**APPROVING CHANGE ORDER NO. 1 WITH
JASPER CONSTRUCTION SERVICES, INC. FOR ADDITIONAL WORK ON
2nd AVENUE BRIDGE OVER DES MOINES RIVER REHABILITATION AND
2nd AVENUE BRIDGE OVER BIRDLAND DRIVE REPLACEMENT,
IN THE AMOUNT OF \$156,341.16**

CHANGE ORDER
For Local Public Agency Projects
No. 1

Accounting ID No. (5-digit number): 38218 Project Number: BRM-SWAP-1945(848)--SG-77
Contract Work Type: Bridge Rehabilitation Local Public Agency: City of Des Moines (Act. ID 12-2019-001)
Contractor: Jasper Construction Services, Inc. (JA250) Date Prepared: July 15, 2022

**SECTION A-A
BACKFILL DETAILS**

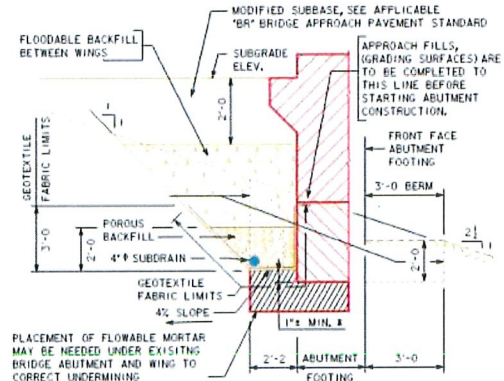
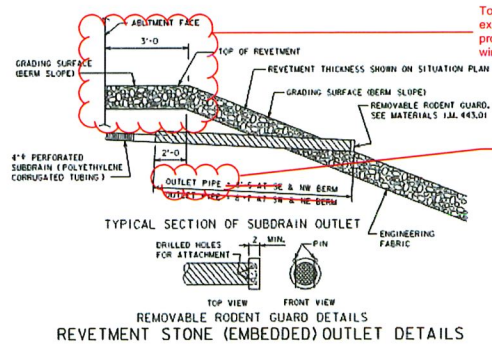
- 8005: Add "Watermain Damage Repair", Bid Item #2599-9999010; Quantity of 1 LS. Item includes all necessary materials, equipment, and labor to repair and restore damage caused by watermain failure as shown on the supplemental plan details as "Attachment 1". Work includes restoring abutment backfill with subdrain, porous backfill, floodable sand backfill, and modified subbase. Slope repair to include minor clearing and grubbing, grading, installation of geotextile fabric and Class E revetment, including accommodating subdrain outlet and re-using existing subdrain outlet. Abutment wing to be backfilled and undermining repaired with flowable mortar. Damaged pavement and sidewalk removed and replaced to restore traffic and east sidewalk. All as-built quantities tabulated.

- 8005: An existing 16" watermain extends across the Des Moines River bridge. The watermain broke behind the existing abutment, causing complete loss of abutment backfill, damaging existing pavement and sidewalks, eroding around the northwest bridge wing and damaging the existing abutment slope. This rupture coincidentally occurred during a road closure period and was not caused by construction work. Due to the nature and location of the rupture, Des Moines Water Works needed the assistance of the contractor to perform the necessary removals and gain access to complete the repairs. DMWW completed the watermain repairs. Since DMWW is not equipped to perform bridge/civil related repairs, it was decided to include these repairs in the contract and DMWW would reimburse the City for their portion of the damage costs.

Place flowable mortar in areas of undermining.

Erosion and undermining around bridge wing and abutment slope

Restore grade behind wing with suitable fill

Remove sand

Remove existing concrete debris, shrubs, roots and place 2 ft. thick Class E revetment protection with engineering fabric w/ new subdrain outlet.

Top of revetment slope to tie into existing concrete slope protection and side of bridge wing extension

Existing outlet pipe may be re-used if salvagable

2nd Ave Bridge – Des Moines Water Works Work Request:

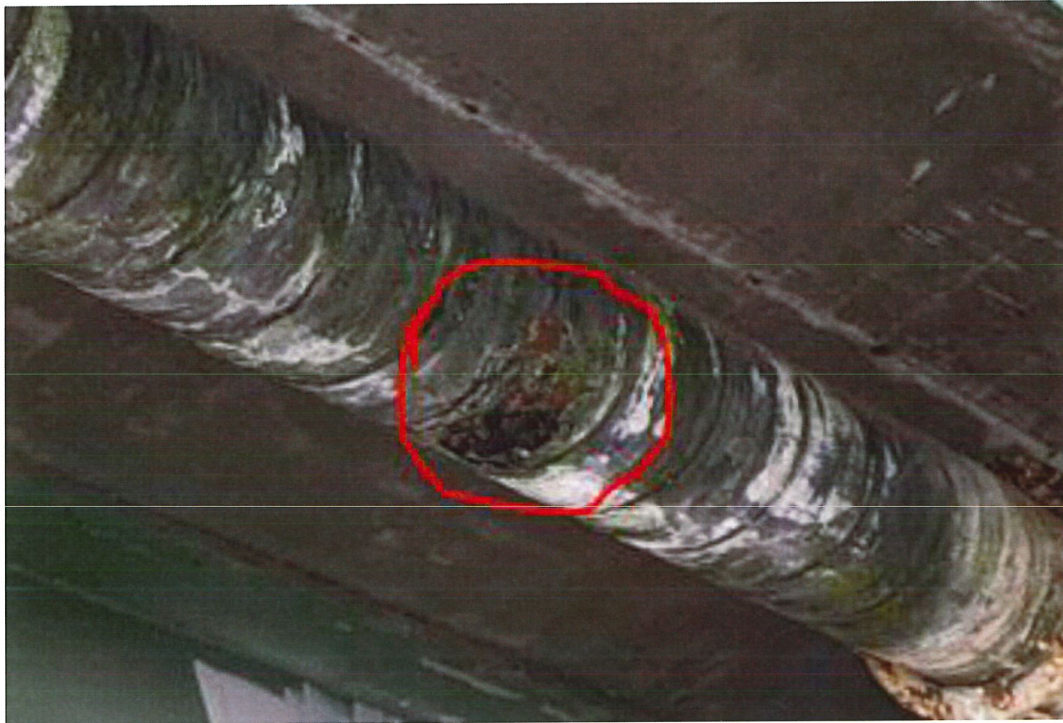
- 8006: Add "Watermain Coating and Joint Repair", Bid Item #2599-9999010; Quantity 1 LS. Item includes all labor, equipment, and materials for work described and illustrated on "Attachment 2" and completion of the work to be coordinated by the contractor with the painter to utilize containment system for access. The exact extents of the work limits may be field adjusted with consultation and concurrence with Des Moines Water Works, which could impact total cost of labor and materials.

- 8006: Des Moines Water Works requested the repairs to be completed concurrently with the bridge project to take advantage of access to the watermain.

Couplings (5 estimated – 3 visible from abutments, 2 anticipated in center spans).

Replace bolts in short coupling adjacent to North Abutment. Match existing bolt type or install stainless steel bolts with suitable stainless steel nuts & washers. Replace bolts 1 at a time to avoid destabilizing coupling. Replacement of additional bolts may be requested on other expansion couplings, not visible from the abutments.

Install Denso Profiling Mastic, Denso Paste, Denso LT Tape, and Denso Glass Outerwrap over each coupling. Follow manufacturers instructions for product application (product literature included at the end of this document). Provide 50% overlap

Unwrapped locations, damaged exiting wrapping (60 ft. of 16" water main estimated length)

Install Denso Paste, Denso LT Tape, and Denso Glass Outerwrap in locations where existing wrap is damaged or missing. Follow manufacturers instructions for product application (product literature included at the end of this document). Provide 50% overlap. Locations to install wrap include:
